INITIAL FIRE SAFETY INSPECTION REPORT

Factory Name: Soultex Fashion Ltd

Date: 05 May 2024

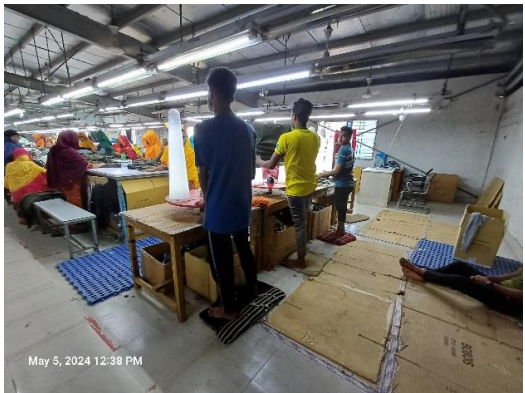
20	Means of egress	Door width found less than 1 meter at exits. Main Building (RC Building (G+4) + Main Shed (G+1))	Doors in a means of egress shall have a minimum width of 1 m (39 in.).	Within 3 months
----	-----------------	---	--	-----------------

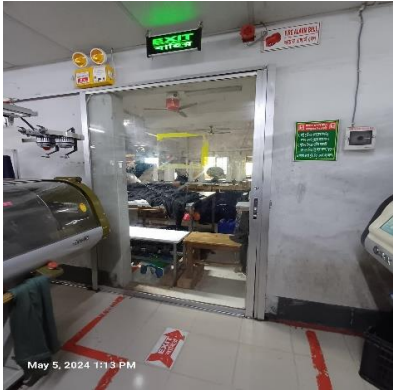
29	Means of egress	Changes in level found exceeding 535 mm (21 in.) at exit. Main Building (RC Building (G+4) + Main Shed (G+1))	Walking surfaces shall be mostly level as per 6.3.5 of The RSC Technical Guidelines (Standard).	Within 2 months
----	-----------------	--	---	-----------------

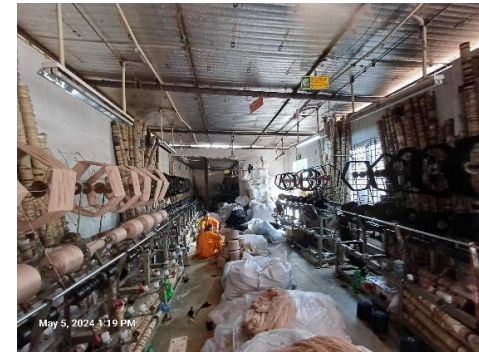
35	Emergency Lighting	Based on the number and location of emergency lights observed, adequate illumination levels are not anticipated along egress routes and at exit stairs on all floors. (All Buildings)	Test the emergency lighting system on each floor and provide additional emergency fixtures to supply adequate illumination along the means of egress. Provide a minimum illumination of 10 lux at the floor level within exit stairs and along exit discharge paths and a minimum 2.5 lux along exit access aisles.	Within 1 month
